CLIENT.:– M/S OSWAL CHEMICALS AND FERTILIZERS LIMITED.

BOILER NO. WA017100
I. D. R.
SCALE 1:30 | DRAWN DM/VK 2/5/03 | CHECKED SDM | APPROVED SDM 6/5/03
DRG.NO. PD1-0FB-04380 REVNO A

INBED EVAPORATOR COIL AND HEADER ASSEMBLY

TOTAL LENGTH OF COIL 6880 mm LG. ⚠

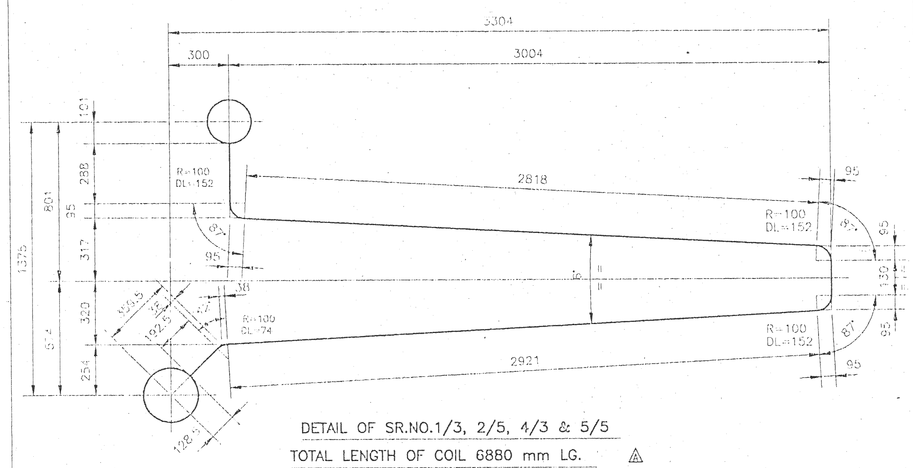
ISSUE NO.	REVISION	MADE BY DATE	CKD CHK'D DATE	APPD BY DATE
⚠	AS BUILT CHANGES DETAIL OF SR.NO.1/3, 2/5, 4/3 & 5/5 TOTAL LG.6910 CHANGED TO 6880. DETAIL OF SR.NO.1/4, 2/6, 4/4 & 5/6 TOTAL LG.6872 CHANGED TO 6853. DETAIL OF COIL NO.2/3,3/3,3/5,3/6,3 TOTAL LG.5054 CHANGED TO 5026. DETAIL OF SR.NO.2/4,3/4,5/4,6/4 TOTAL LG.5008 CHANGED TO 4971. R=76.2 CHANGED TO 100. CORRESPONDING DIMENSIONS CHANGED.
